Check report by Sales + CR after finishing stage IV (Apartments)

Flat No	501	Other		Sl. No.	43060
Company	NRGV LLP	Project	BRGV	Phase	
Prepared by	Venkatesh Reddy	Sign	<i>[Signature]</i>	Date	6/8/24
Project Manager	Sarwan	Sign	<i>[Signature]</i>	Date	08/08/24
Stage II report no.					
Checked By MD on		MD Sign		For filling	☐ Yes ☐ No
Recommendation: ☐ Work is satisfactorily completed. Possession may be handed over. ☒ Minor corrections given herein to be completed before handing over possession. ☐ Major corrections required. Do not handover possession. Request for recheck after completion of works. ☐ Works incomplete. Check report cannot be prepared. Request for recheck after completion of works.

Quality Control Check Report. Stage: After Finishing Stage III (Apartments)

Quality Control Check Report. Stage: After Finishing Stage II (Apartments)

ELECTRICAL PLAN

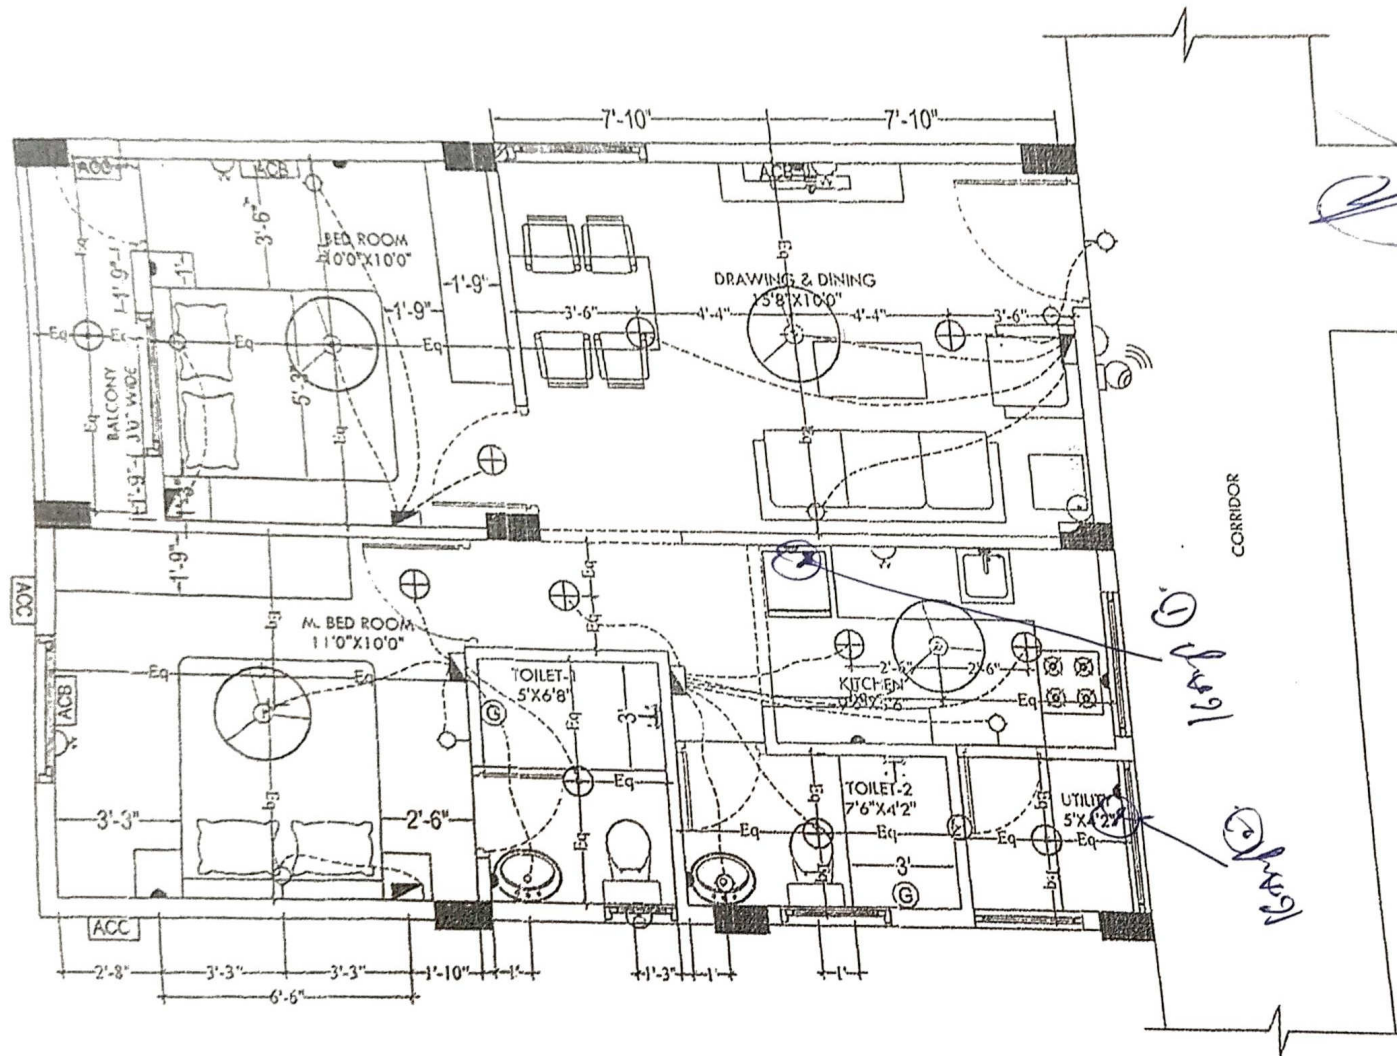
Changes in electrical points: (mark on plan)

① 16 amp & 10 amp in kitchen
